INDIANA DEPARTMENT OF TRANSPORTATION

STANDARDS COMMITTEE MEETING AGENDA

RE: Agenda for the June 22, 2006 Standards Committee Meeting

REVISION TO 2006 STANDARD SPECIFICATIONS

707-SDPC-01, AASHTO Type II, III, or IV I-Beams
707-SDPC-02, Indiana 54" Bulb-Tees
707-SDPC-03, Indiana Bulb Tees Greater Than 54" in Depth

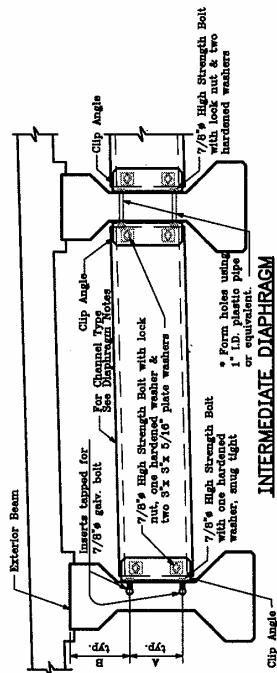
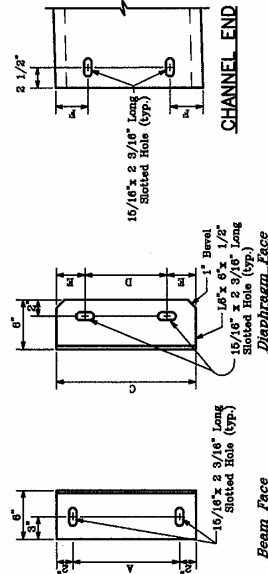
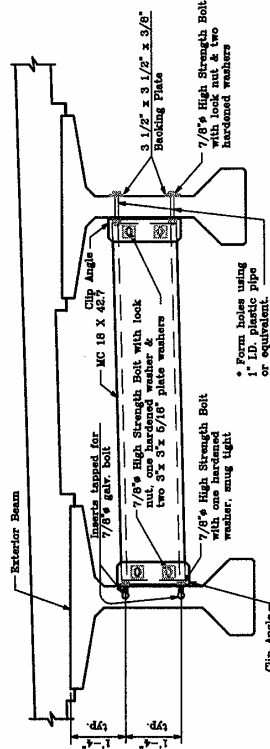
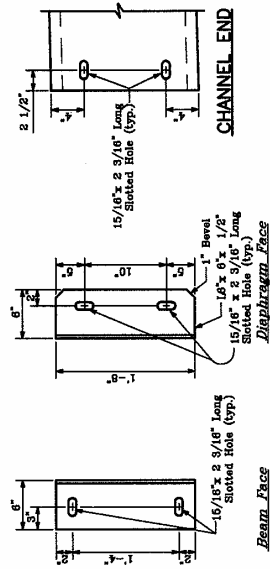
In recent past Division of Design has received several requests to replace concrete diaphragms with steel diaphragms for prestressed concrete beam structures.

ASCE-INDOT Structural Subcommittee has considered and approved the use of the steel diaphragms. We have also attached a letter from Mr. Greg Kisinski, Design/Build Project Manager and an e-mail from Mr. Derek Merida, contractor on I-465 and 71st and 86th Street project, explaining need and benefits of such diaphragms.

Division of Design desires to create a set of standard drawings and special provisions for the use of steel interior diaphragms for concrete beam structures.

Last winter a design/build contractor requested the opinion of the structural committee on the use of steel cross frames in place of the standard concrete diaphragms that are traditionally used in the State of Indiana. The opinion was offered that the steel cross frames could be used in our case.

From a constructability point of view, the use of the galvanized steel cross frames offered a number of advantages over concrete diaphragms.

Steel cross frames are placed while the beams are being set adding very little if any time to the beam setting operation. This actually aids in setting the beams by helping to set the proper beam spacing. It also provides instant beam stability.

Structural steel for steel intermediate diaphragms shall be in accordance with 910.02(a) and shall be galvanized in accordance with ASTM A 123 after cutting, bending, and welding. Bolts for steel intermediate diaphragms shall be 7/8 in. (22 mm) and in accordance with 910.02(e)1, except they shall be type 1. All bolts, nuts, washers, and similar threaded fasteners shall be galvanized in accordance with ASTM A 123 or may be mechanically zinc coated in accordance with ASTM B 695, class 50.

Structural steel diaphragms shall be fabricated and erected in accordance with 711. Steel diaphragms shall include all connection angles, plates, and associated hardware required for a complete installation. The Contractor shall replace, re-galvanize, or repair all damaged galvanized material at the discretion of the Engineer.

The cost of all materials, including galvanizing, labor, and equipment for furnishing and installing steel intermediate diaphragms shall be included in the cost of structural member, concrete of the type and size specified.

Structural-steel interior diaphragms should be specified if interior diaphragms are required for a prestressed-concrete-members bridge. This use of structural steel instead of concrete does not affect the bridge design. Structural-steel interior diaphragms should be detailed on the plans. Steel interior diaphragms are not a separate pay item. Their cost should be included in that of the concrete structural members. However, the quantities of pounds (kilograms) should be shown in the superstructure bill of materials and on the Bridge Summary sheet.
